Before the Proposed Te Tai o Poutini Plan - A Combined District Plan for the West Coast, Hearings Panel

Under	the Resource Management Act 1991 (the Act)
In the matter of	the Proposed Te Tai o Poutini Plan: A Combined District Plan for the West Coast – Hearing Topic 4
	Energy, Infrastructure, Transport
Between	Te Tai o Poutini Plan Committee Comprising the Buller, Grey and Westland District Councils
And	Transpower New Zealand Limited Submitter 299 and Further Submitter FS110

<u>Addendum</u> Statement of evidence of Pauline Mary Whitney for Transpower New Zealand Limited

Dated 27 November 2023

Figure 1. 110kV Dobson Tee A line

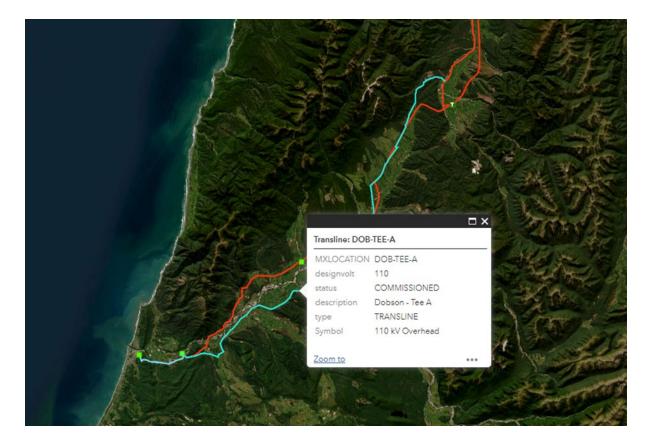
1.7. As noted in my primary evidence, the West Coast region is somewhat unique in that it has a line that is not subject to the NESETA (as the line was not owned and operated by Transpower at the time the NESETA came into effect). This line is the 110kV Dobson Tee A line which runs from the Dobson substation east of Greymouth to Reefton. The line is significant in its length, as shown in light blue in Figure 1 below.

1.8. Given the NESETA does not apply to the operation, maintenance, repair and upgrade of the line, rule ENG-R4 is very important to ensure an appropriate rule framework is provided in the pTTPP for Transpower to undertake work on the line to ensure the safe and efficient electricity transmission (as required by the NPSET).
